Specht Road CIP 16" Water Main – Phase 1 Improvements
Solicitation Number: CO-00522
Job No.: 20-1082

ADDENDUM 1
February 9, 2021

SPECHT ROAD CIP 16" WATER MAIN - PHASE 1 IMPROVEMENTS
WATER DISTRIBUTION STANDARD DETAILS

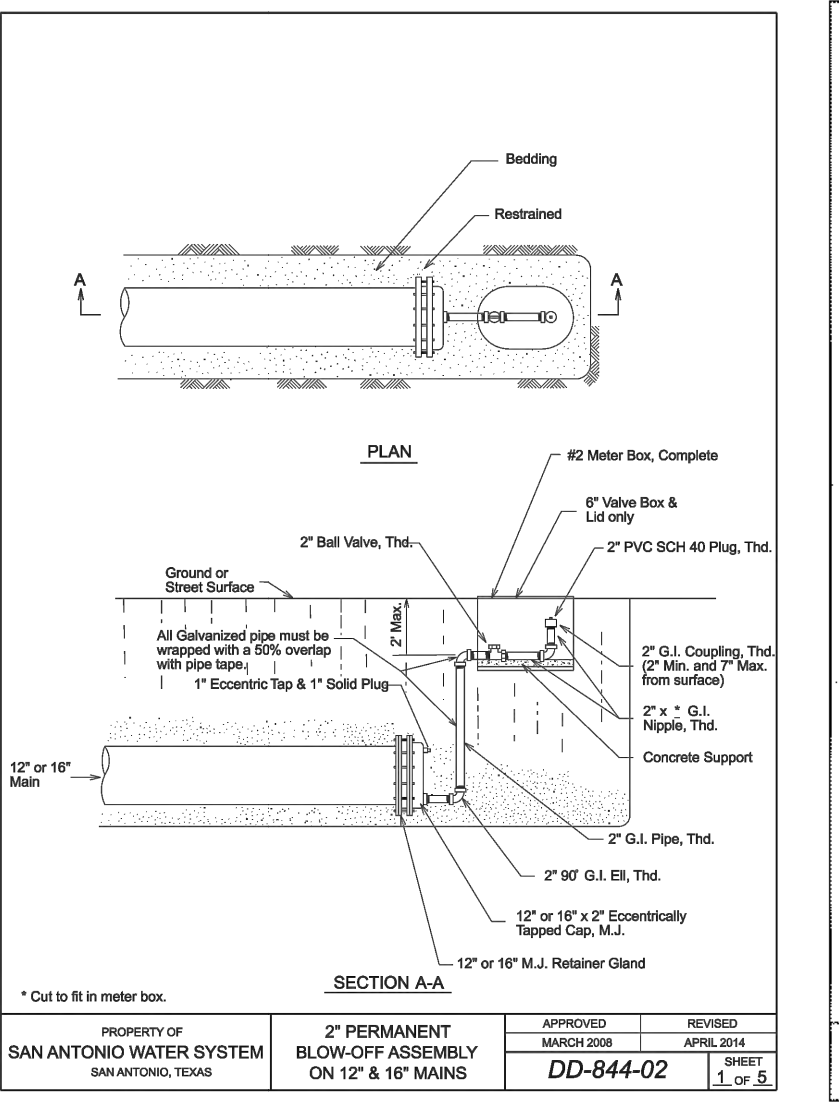
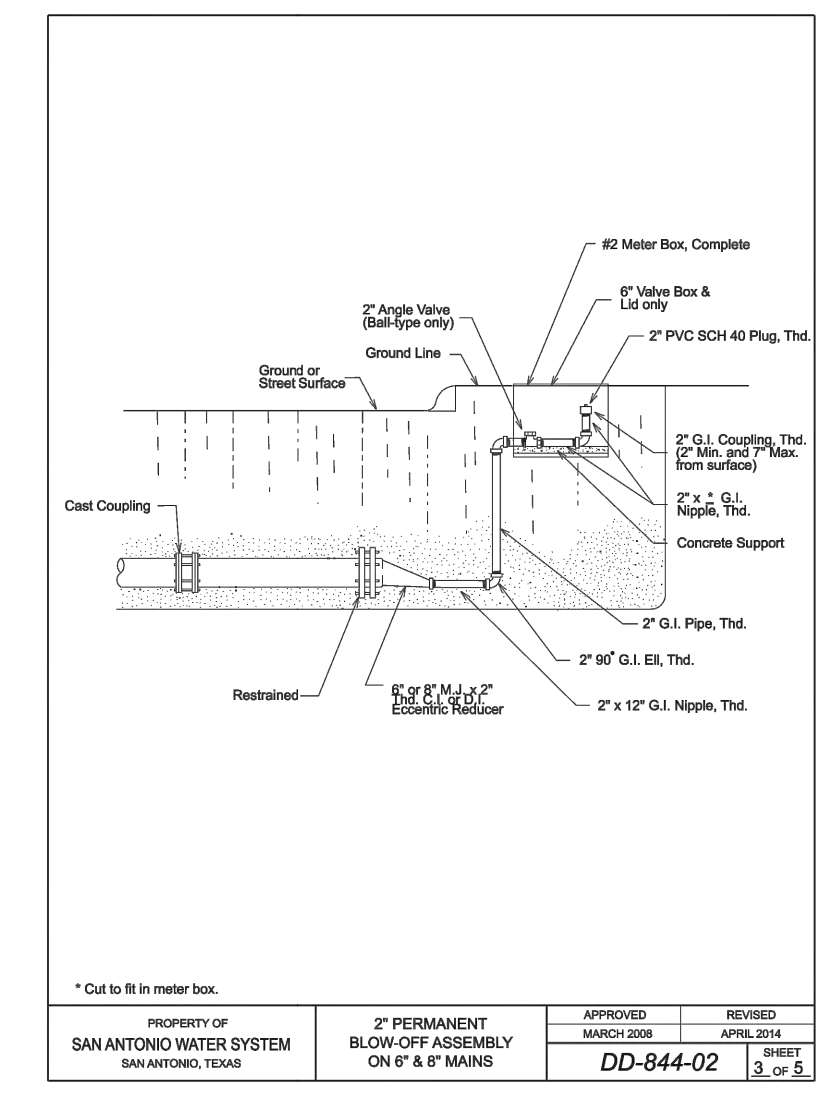
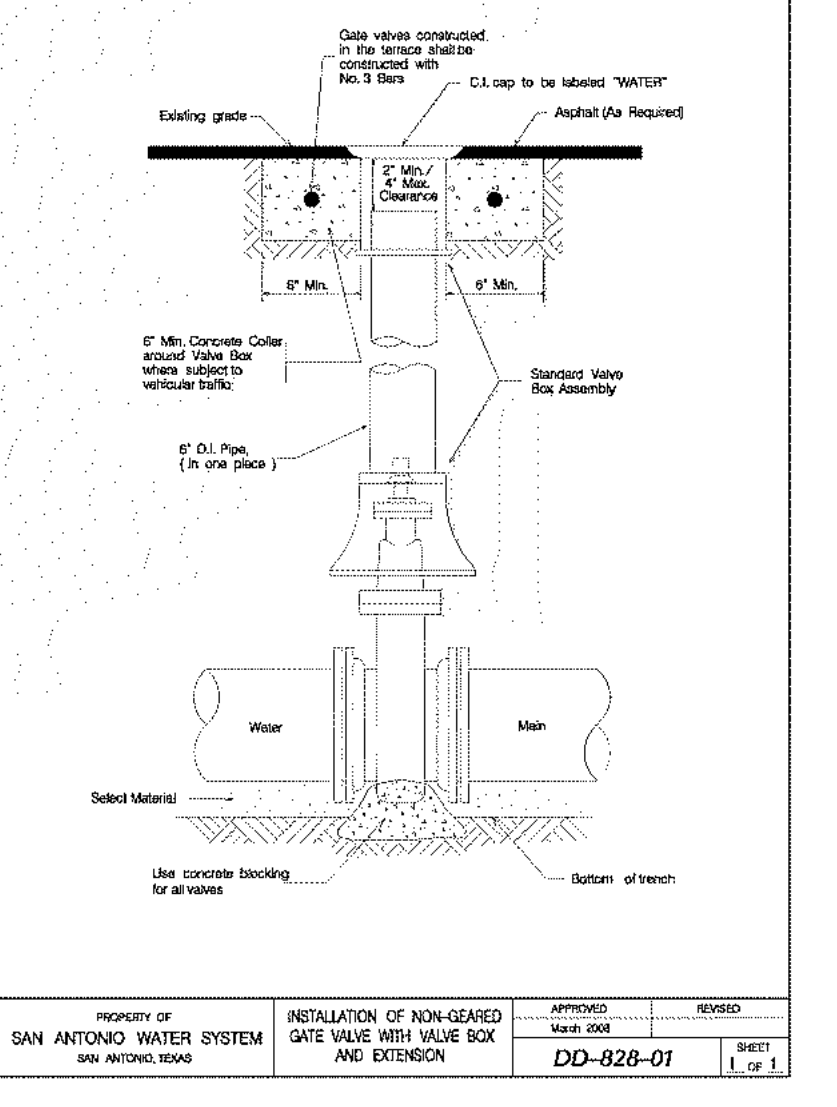
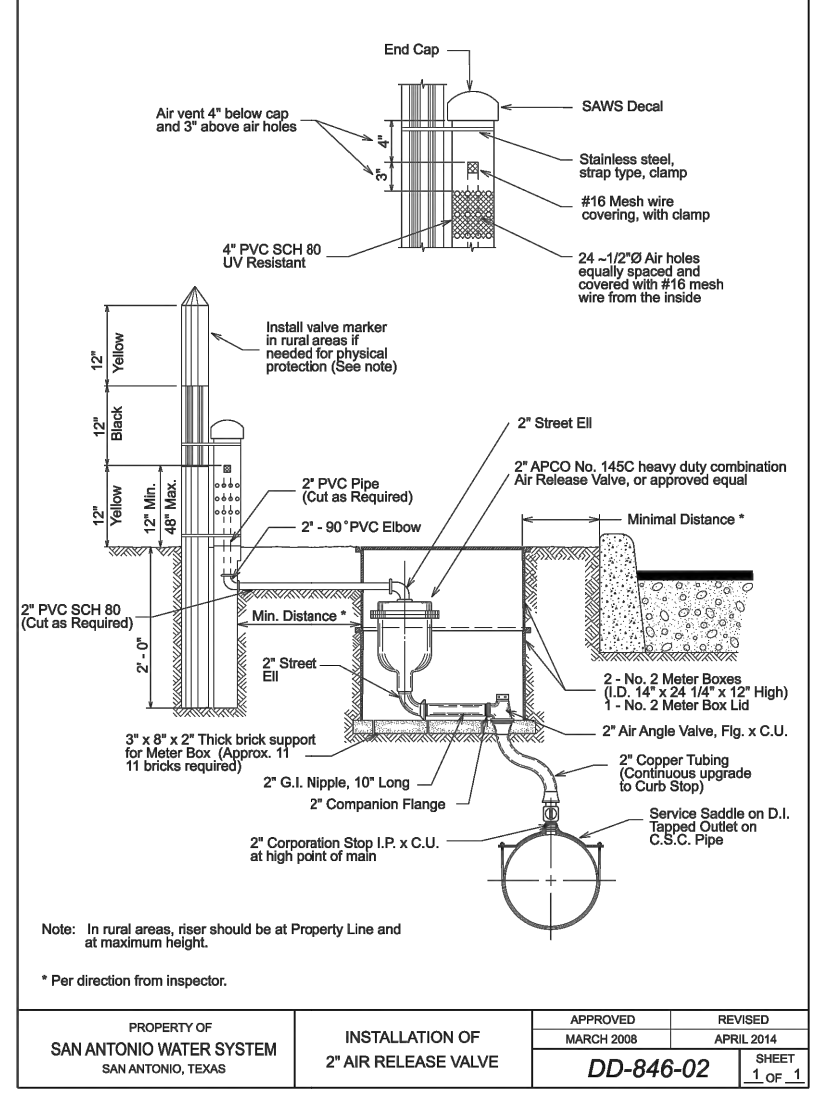
Response: This pipe is an allowable alternate material.
- 15. Question: Will pipe be required to be restrained? If so, please provide a restraint chart for both 16" DR18 C905 235 psi PVC pipe and 16" PC250 ductile iron pipe.**

Response: Yes, pipes will need to be restrained. Table is provided on sheet C13. Detail DD-839-05.

C17

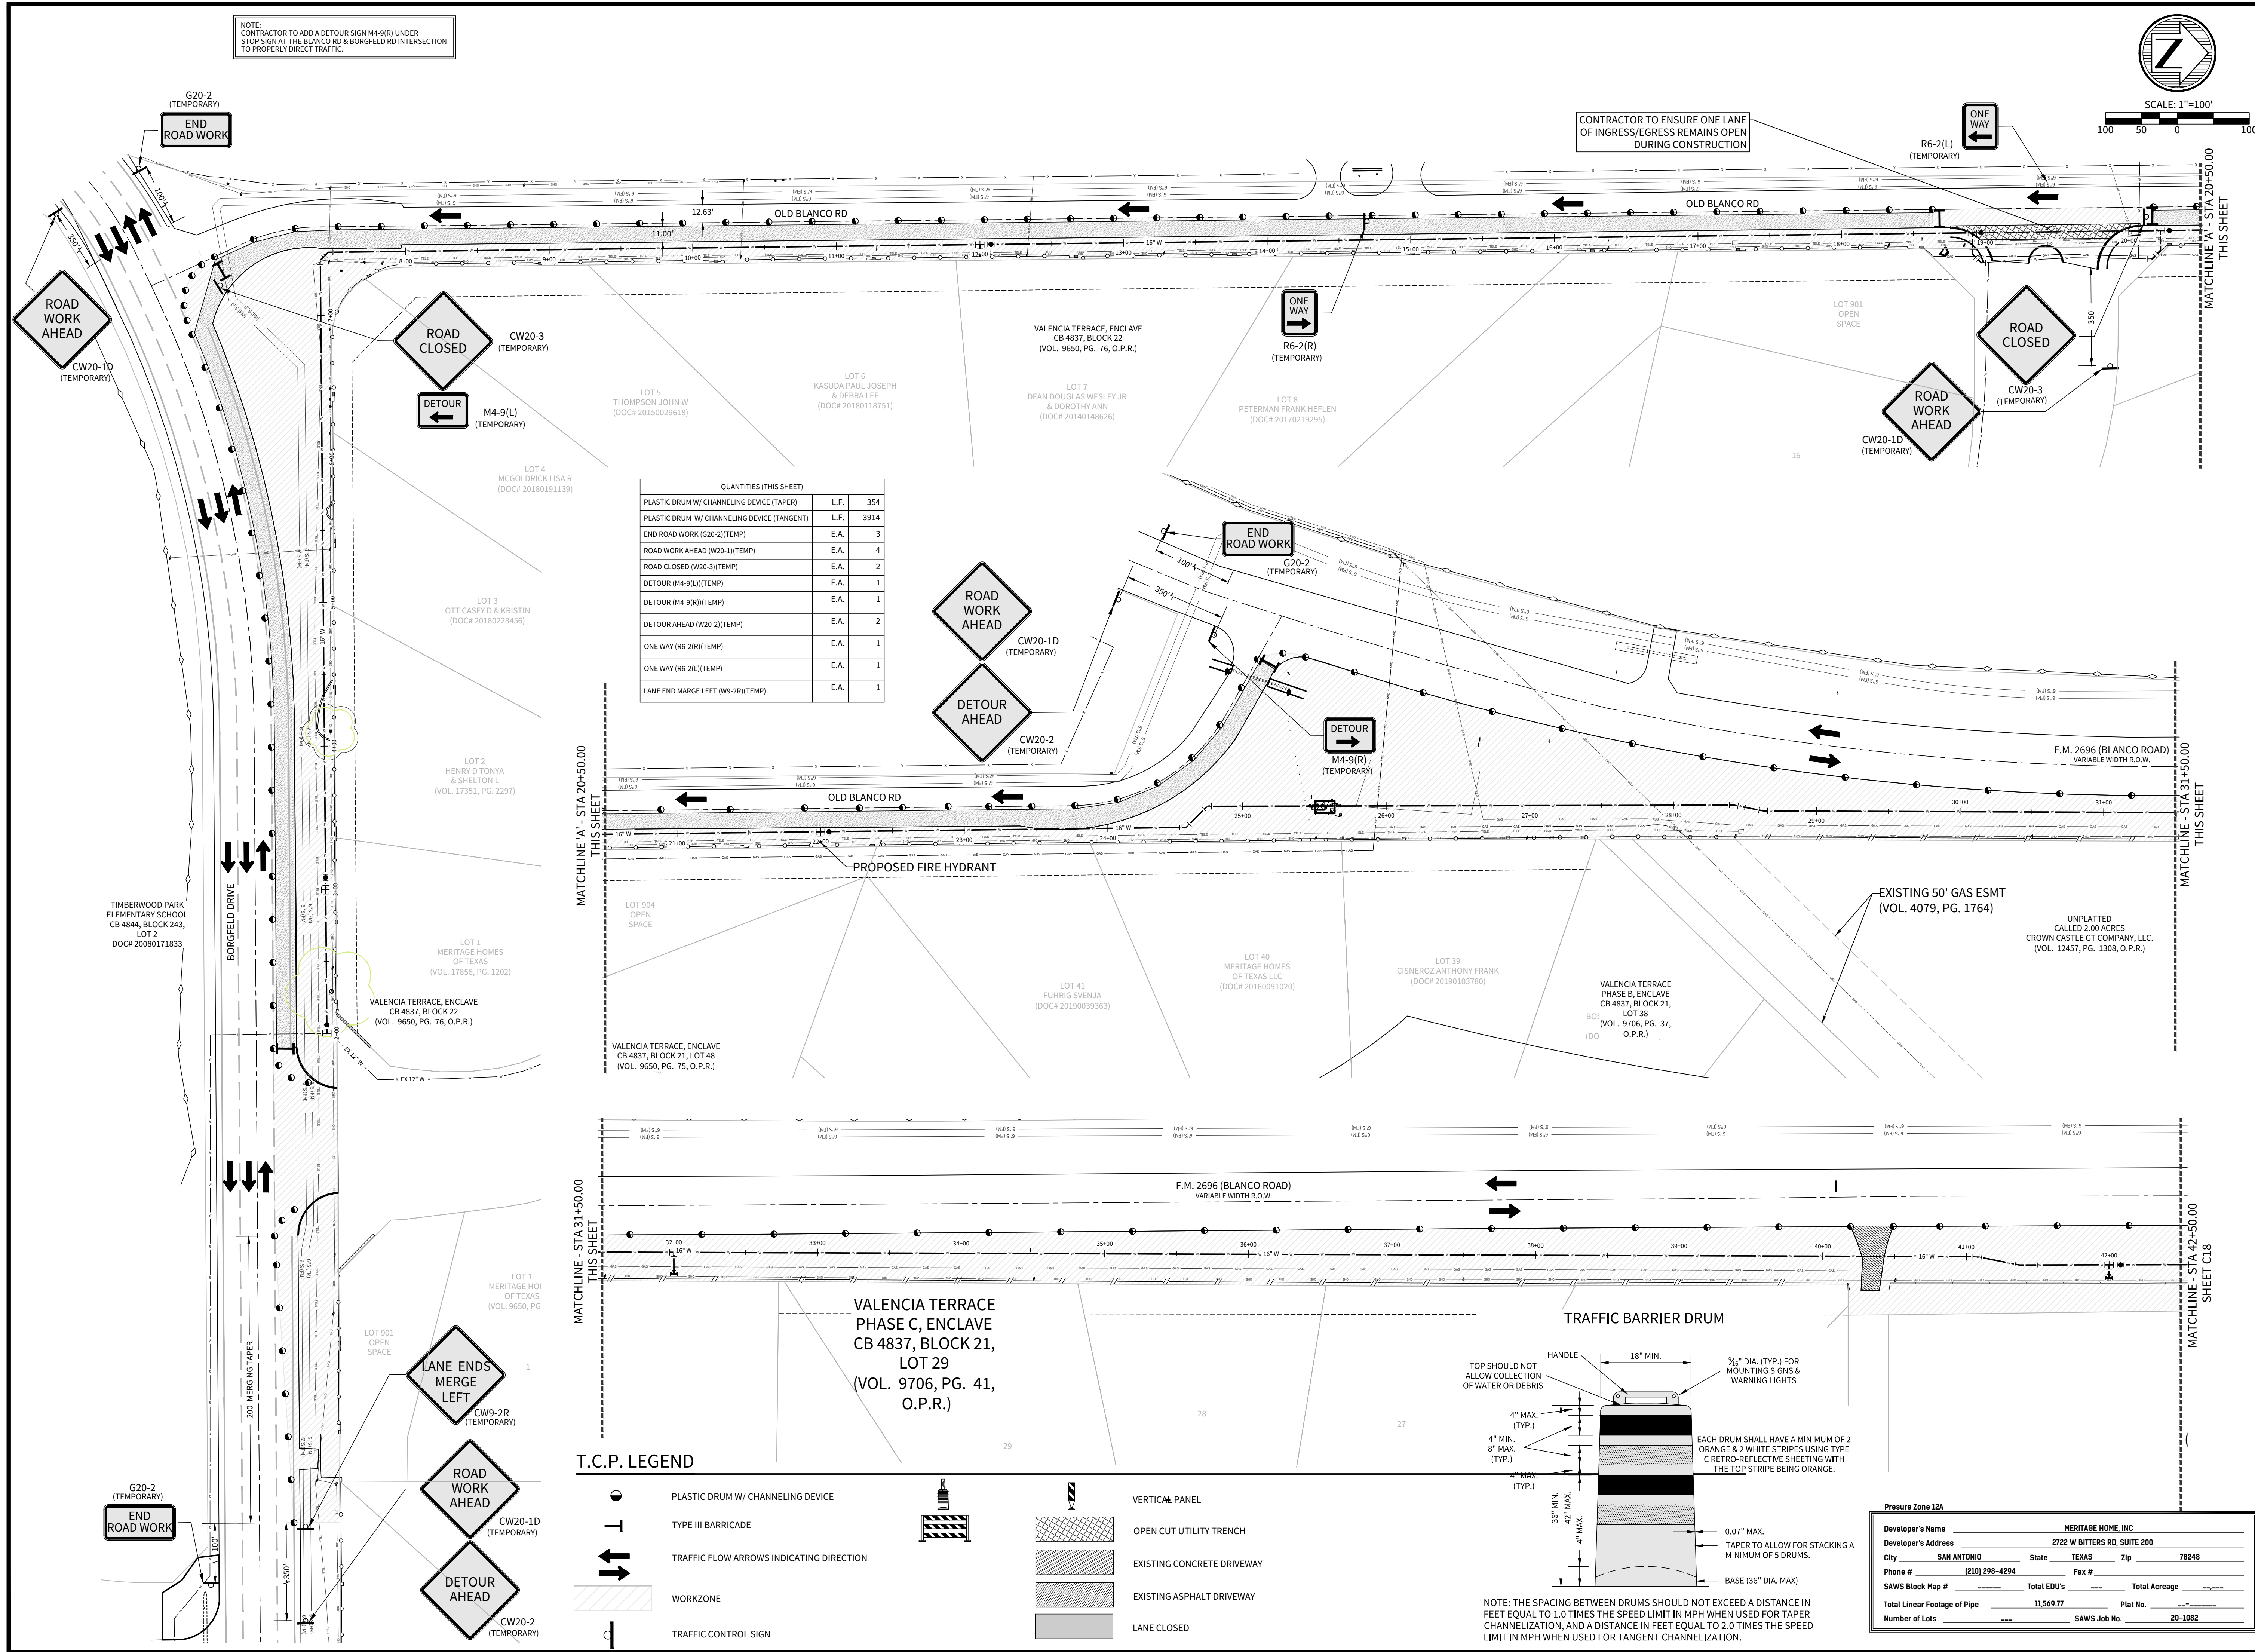
- 2. Question: Will the appropriate bid item be added for barricading and traffic control?**
Response: Line item 21 has been added to the attached, revised Bid Form for traffic control. This line item shall include barricades.

1. Remove sheets C5, C6, and C10. Replace with new sheets C5, C6, and C10 included with this addendum.
2. Add sheets C13 through C24, included with this addendum, to the plan set.
